Access Compliance Report

Public Rights-of-Way

Intersection ID: 15803	Main Street: CLANTON_RD	Cross Street: DEWITT_LN	Location: SE
ADA ID: E185F466C415	Ramp Type: PerpDiag	Initial Pass/Fail: Fail	Overall Compliance: No
Severity Score: 8.75			
Codes/Mitigation Info/Possible Solution		Field Measurements/Component Compliance

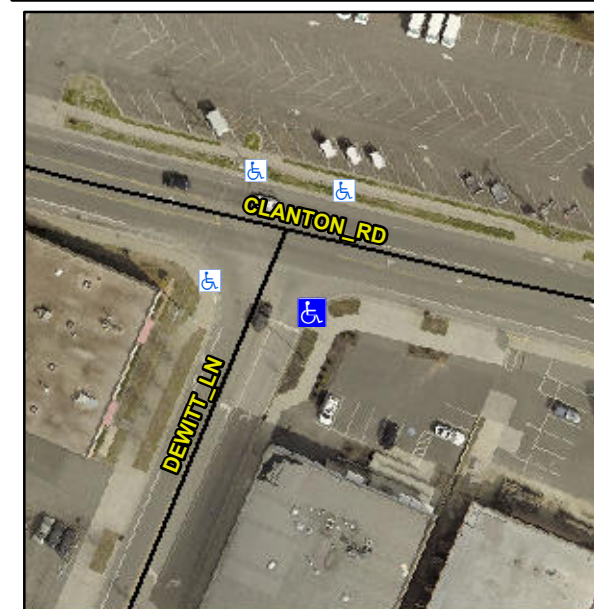
Not Found, R304.5.1

Compliance	Description	Data	Compliance	Description	Data
N/A	Ramp Length (in)	71.0	Yes	Ramp Slope (%)	6.6
No	Ramp Width (in)	46.5	Yes	Ramp XSlope (%)	2.0
N/A	Flare Type LT	N/A	N/A	Flare Type RT	N/A
N/A	Flare Slope LT (%)	N/A	N/A	Flare Slope RT (%)	N/A
N/A	Flare Traversable LT?	N/A	N/A	Flare Traversable RT?	N/A
N/A	Landing Length (in)	N/A	N/A	DWS Provided?	N/A
N/A	Landing Width (in)	N/A	N/A	DWS Contrast?	N/A
N/A	Landing Slope (%)	N/A	N/A	DWS Length (in)	N/A
N/A	Landing X Slope (%)	N/A	N/A	DWS Full Width?	N/A
N/A	Landing Curb? (Y/N)	N/A	N/A	DWS Offset (in)	N/A
N/A	Shared Landing?	N/A			
N/A	Gutter Ponding?	N/A	N/A	Gutter Slope (%)	N/A
N/A	Gutter Lip Ht (in)	N/A	N/A	Gutter X Slope (%)	N/A
N/A	Painted X Walk1?	No	N/A	Painted X Walk2?	No
	X Walk 1 Direction	To NE		X Walk 2 Direction	To NW
N/A	X Walk 1 Width (in)	N/A	N/A	X Walk 2 Width (in)	N/A
	X Walk 1 Slope (%)	0.4		X Walk 2 Slope (%)	0.8
	X Walk 1 X Slope (%)	2.4		X Walk 2 X Slope (%)	1.3

Remove & Replace Curb Ramp With Two New Directional Ramps or Equivalent.
